Subject: Revision to Unit 2 and Unit 3 Cycle 17 Core Operating Limits Report

Core Operating Limits Report

Dresden Station

Cycle 17

FIGURE 2.2-1

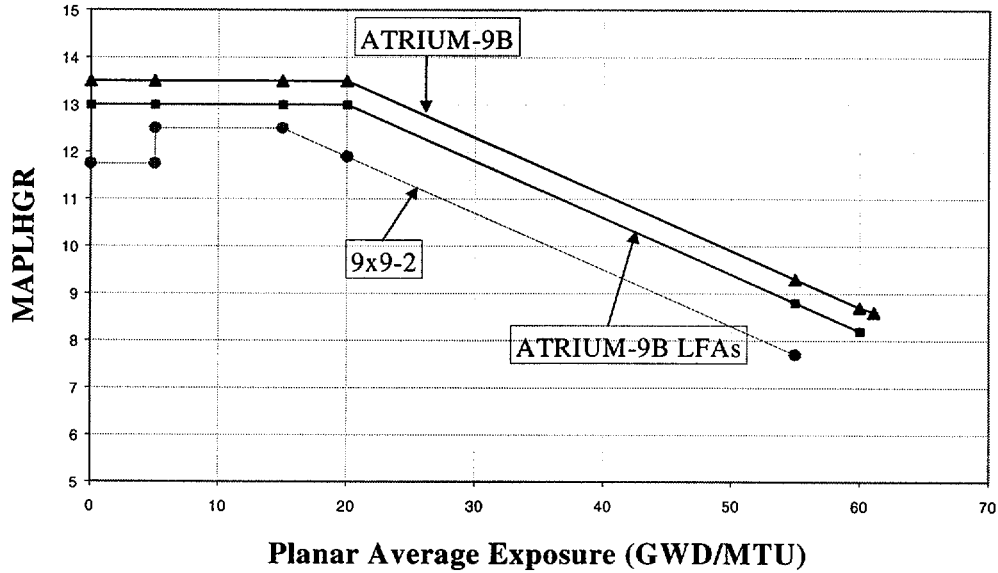
| Affected Section | Affected Pages | Summary of Changes | Date |
|--|---------------------------------------|--|----------|
| Figure 2.2-1 | 2-2 | Figure 2.2-1 and the table below the figure were revised to reflect how the limits are implemented into the core monitoring code ¹ . | 10/12/99 |

¹ Powerplex can not implement a step change in an operating limit. Therefore, the COLR was revised to reflect a conservative implementation method for use in the Powerplex input deck.

FIGURE 5.2-1

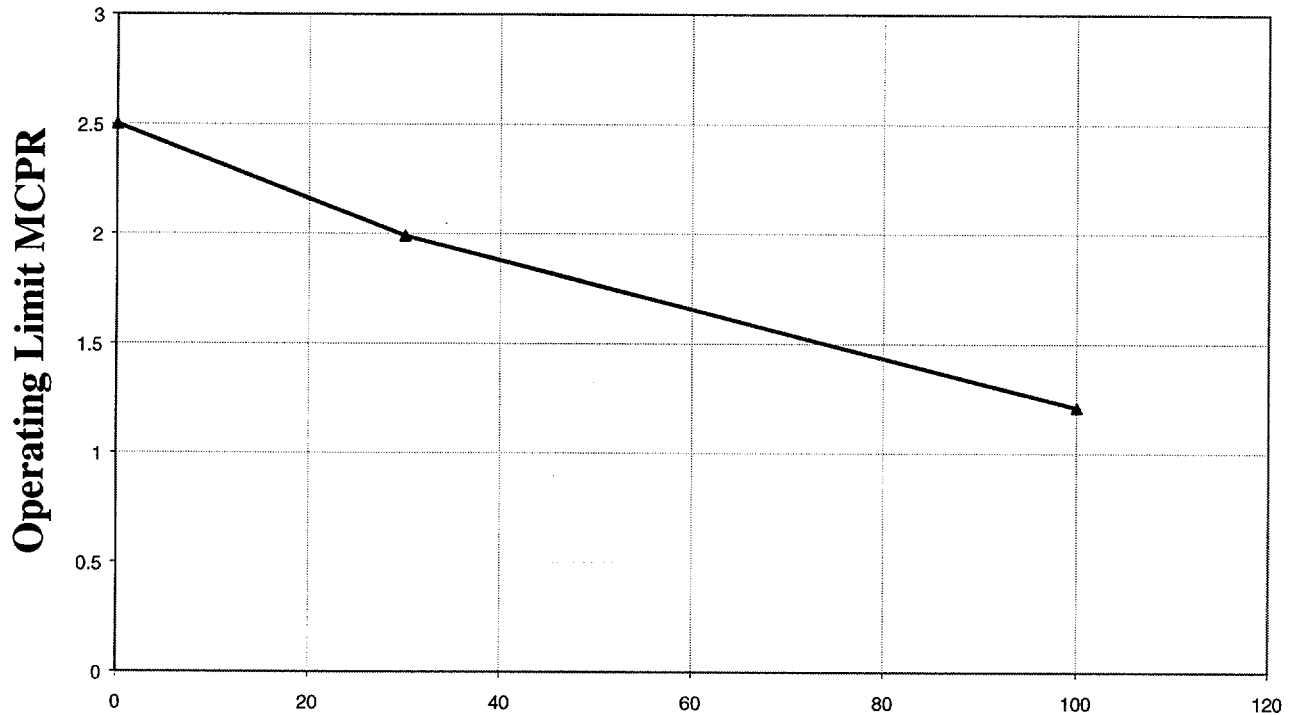
| Affected Section | Affected Pages | Summary of Changes | Date |
|--|---------------------------------------|--|----------|
| 1.1, 2.1, Table 2.3-1, 3.1, 4.1, 5.1, 5.2.a, Figure 5.2-1, 6.1 | 1-1, 2-1, 2-3, 3-1, 4-1, 5-1 5-4, 6-1 | Include ITS in Technical Specification references | 3/01 |
